## Comments on Volume 6 Environmental Statement 6.2.5 Air Quality submitted at Deadline 7.

The figure below is the applicants map from Appendix A figure 4. Why is this map so different to the National Grids even though it is from the British National Grids map?

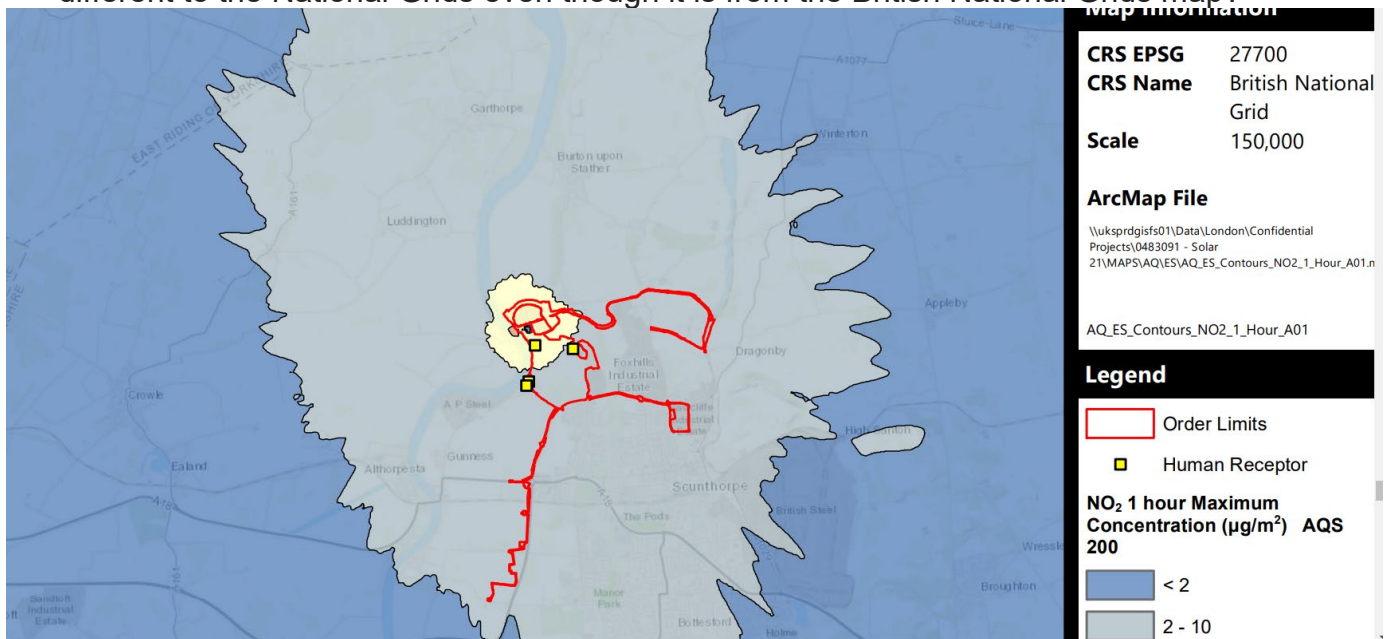
With reference to Appendix A, pages 97 to 107 of the report, particularly Figures 4 to 8 on pages 102 to 106. Can the applicant explain why both Amcotts and Flixborough villages' names have been omitted from the pollution map when these two receptors are going to be impacted by the N20, NOx and PM10 the most, apart from the order limits? Is the applicant trying to make the public believe there are no nearby villages that will be affected by the pollution that the proposed development will emit? I find it hard to understand why the villages that are going to be impacted less by the pollutants have been included and the ones which will feel the impact the most have been omitted.

Also, the map British National Grid uses for planning purposes clearly identify the villages of Amcotts and Flixborough so why do the maps that the applicant has used in appendix A not align with this when it apparently comes from the same source?

Why in Appendix A do Figures 1a,1b, 4,5,6,7 and 8 only identify 4 human receptors, none of which are the villages directly impacted by the project. Some human receptors identified are further away from the order limits than the villages of Amcotts and Flixborough.
